UNITED STATES PATENT AND TRADEMARK OFFICE

Office Action Summary

10/531,925

DETAILED ACTION

U.S. Patent Aug. 31, 2001 Sheet 1 of 3 US 6,376,999 B1
 Fig. 1

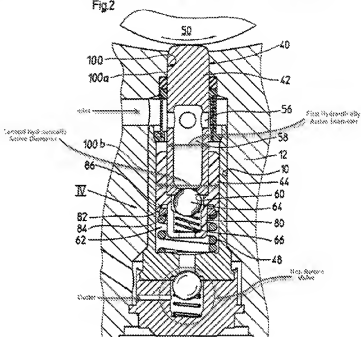
In regards to claim 11 Siegel et al. discloses: a piston pump, or supply device for a hydraulic brake system with a pressure fluid inlet and a pressure fluid outlet (see features labeled in Fig. 2 by the examiner for clarity); a piston (40) movably arranged in an accommodating member (12) and at least two hydraulically active diameters for supply in the direction of the pressure fluid outlet (see Fig. 2 labeled by the examiner for clarity); a non-return valve (26, 62) used for ventilating a working chamber (78) into which the piston (40) is immersed (see Fig. 1-2 and column 4, lines 55-60); a multi-part design piston (40) comprising at least two synchronously moveable partial pistons (42 and 44) wherein the first partial piston (42) exhibits a first hydraulically active diameter and a second partial piston (44) exhibiting a second hydraulically active diameter (see Fig. 2 labeled by the examiner for clarity).

In regards to the claim limitation set forth by the applicant wherein the piston "has a multi-part design" the applicant gives no clear indication that the piston is formed from an arrangement of separable parts or individual elements. Therefore in examining by means of the broadest reasonable interpretation, the examiner notes that the prior art according to Siegel et al. does disclose an equivalent piston (40) comprising of multiple parts (42, 44) or "a multi-part design" as indicated by the applicant.

U.S. Patent Aug. 31, 2001 Sheet 2 of 3 US 6,376,999 B1
 Fig. 2

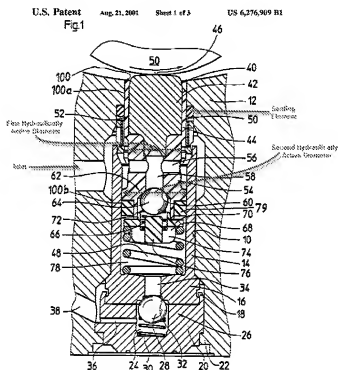
With respect to claim 12 and 13, it can be seen in Fig. 2 according to Siegel et al. that the first partial piston (42) is configured in an analogous manner to that of the applicant allowing for the first partial piston (42) to be provided as a rolling bearing needle. Furthermore, it is disclosed by Siegel et al. that the second partial piston (44) is made of plastic (see column 1, line 19-35 and column 4, lines 24-28). In regards to the claims reciting that the second partial piston is formed from plastic through the process of molding, it is considered by the examiner as a product by process and therefore does not distinguish itself as patentably distinct over the prior art.

In regards to claim 14 Siegel et al. discloses: a piston pump, or supply device as indicated by the applicant, for a hydraulic brake system with a pressure fluid inlet and a pressure fluid outlet (36) (see Fig. 1 labeled by the examiner for clarity); a piston (40) movably arranged in an accommodating member (12) and at least two hydraulically

active diameters for supply in the direction of the pressure fluid outlet (36) (see Fig. 1 labeled by the examiner for clarity); a non-return valve (62) used for ventilating a working chamber (78) into which the piston is immersed wherein a first partial piston (42) and a second partial piston (54) are arranged and guided so as to be movable guided in the accommodating member (12) (see Fig. 1 and column 3, line 26-35).

With respect to claim 15 Siegel et al. discloses a sealing element (79) associated with the first partial piston (42) and a sealing element (feature labeled by the examiner in Fig. 1) associated with the second partial piston (54). It can be visually seen in Fig. 1 that both sealing elements are utilized for sealing the working chamber (78) (see Fig. 1 provided above).

In regards to claim 16 Siegel et al. discloses a second partial piston (54) includes a sealing seat (60) for a valve member (64) of the non-return valve (62) (see Fig. 1).

With respect to claim 17 it can be seen in Fig. 1 according to Siegel et al. that the non-return valve (62) is arranged in a similar manner as described by the applicant whereby the non-return valve (62) is integrated into the second partial piston (54).

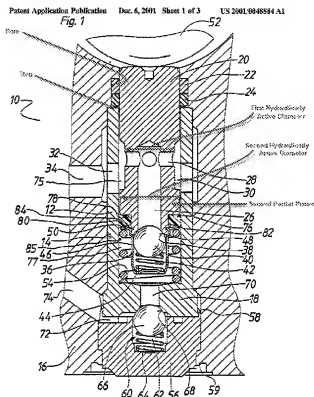
In regards to claim 18 the arrangement of the non-return valves according to Siegel et al. are analogous to the non-return valves provided by the applicant. Siegel et al. Discloses non-return valve (62) configured as a suction valve and an additional non-return valve (26) designed as a pressure valve having a sealing seat (32) provided at a base member (16) that includes a casing (14) in which the second partial piston (54) is received (see Fig. 1).

In regards to claim 19 Siegel et al. discloses: a piston pump, or a supply device as claimed by the applicant, for a hydraulic brake system with a pressure fluid inlet (34) and a fluid pressure outlet (74); a piston (20) moveably arranged in an accommodating member (16) and at least two hydraulically active diameters for supply in the direction of the pressure fluid outlet (74) (see Fig. 1 labeled by the examiner for clarity provided below); a non-return valve (36) configured as a suction valve and an addition non-return valve (60) designed as a pressure valve having a sealing seat (68) provided at a base member (18) that includes a casing (12) in which the second partial piston is received (see feature labeled by the examiner in Fig. 1), wherein the casing (12) has a stop at its

end for securing a sealing element (24) in position in a bore of the accommodating member (16) (see Fig. 1 labeled by the examiner for clarity).

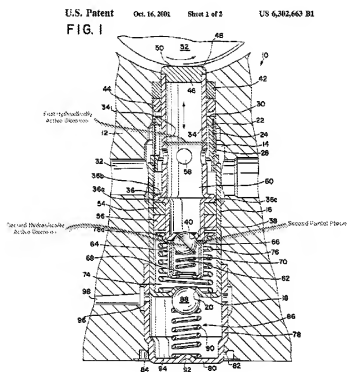
In regards to claim 20 Schuller et al. discloses: a piston pump for a hydraulic vehicle brake system (10), or supply device for the supply of pressure fluid into at least one vehicle brake as claimed by the applicant, with a pressure fluid inlet (32) and a pressure fluid outlet (98); a piston (34) is movably arranged in an accommodating member (12) and has at least two hydraulically active diameters for supply in the direction of the pressure fluid outlet (98) (see Fig. 1 labeled by the examiner for clarity);

at least one non-return valve (86) for ventilating the working chamber (74) into which the piston is immersed; a second partial piston designed as a ball wherein the ball is arranged and guided in a casing (16) of a base member (18) for a non-return valve (86) (see Fig. 1 labeled by the examiner for clarity provided below).

In regards to claim 20, the non-return valve (86) is designed as an integral sleeve-type non return valve.
